Seven County Infrastructure Coalition's Response to the
STB Office of Environmental Analysis October 30, 2019
Request for Information No. 4

November 20, 2019

Figure 1: Map of Avintaquin Canyon Route
(Not-to-Scale)

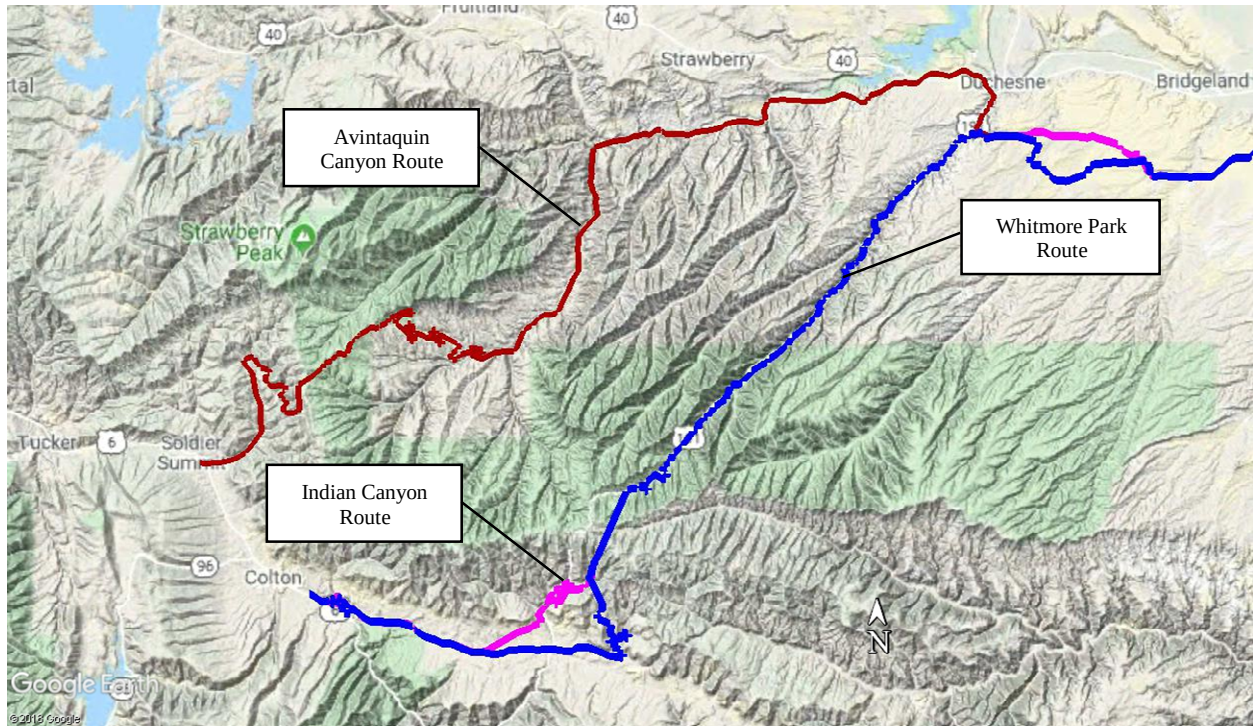
c. Please provide any additional information (such as ruling grade, curve radius, cut-and-fill volumes, or tunnel design details) that the Coalition considered in evaluating the feasibility of the Avintaquin Canyon Route.

Coalition Response: The Avintaquin Canyon Route was based on a route surveyed, but never constructed, by the D&RGW Railway in 1925. The D&RGW Railway route was used as a starting point and modified as appropriate to achieve proposed design standards for the Uinta Basin Railway. A map of the Avintaquin Canyon Route, identified by the red route line, is provided in Figure 1. In order to achieve the maximum gradient established for the Uinta Basin Railway, the route follows a circuitous path that lies on angle-of-repose mountain slopes. This circuitous path is necessary both to avoid areas of great relief and tunneling, as well as to meet maximum grade requirements.

The Avintaquin Canyon Route was thoroughly evaluated and withdrawn from further consideration in the spring of 2019. The decision to remove this route from further consideration was based primarily on the considerable engineering challenges associated with the extremely rugged topography along the Avintaquin Canyon Route.
